UNITED STATES PATENT AND TRADEMARK OFFICE

APPLICATION NO.	FILING DATE	FIRST NAMED INVENTOR	ATTORNEY DOCKET NO.	CONFIRMATION NO.
10/008,766	11/07/2001	Robert H. Mimlitch III	50097-00003PT	9188
26231	7590	05/06/2004	EXAMINER	
FISH & RICHARDSON P.C. 5000 BANK ONE CENTER 1717 MAIN STREET DALLAS, TX 75201			FERGUSON, MICHAEL P	
			ART UNIT	PAPER NUMBER
			3679

Office Action Summary	Application No.	Applicant(s)
	10/008,766	MIMLITCH ET AL.
	Examiner Michael P. Ferguson	Art Unit 3679

DETAILED ACTION

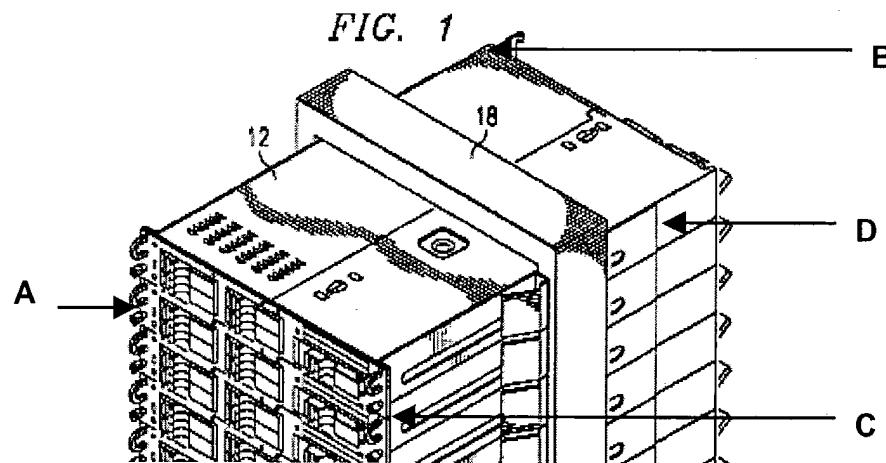
As to claim 32, Jensen et al. discloses a modified two-post rack comprising:
a third coupling member **20** coupled to and independently extending substantially horizontally outward from a first post; and
a fourth coupling member **20** coupled to and independently extending substantially horizontally outward from a second post, first, second, third and fourth coupling members each substantially replicating a different vertical upright **A,B,C,D** (Figure 1 reprinted with annotations below) in a four-post equipment rack (Figure 1).
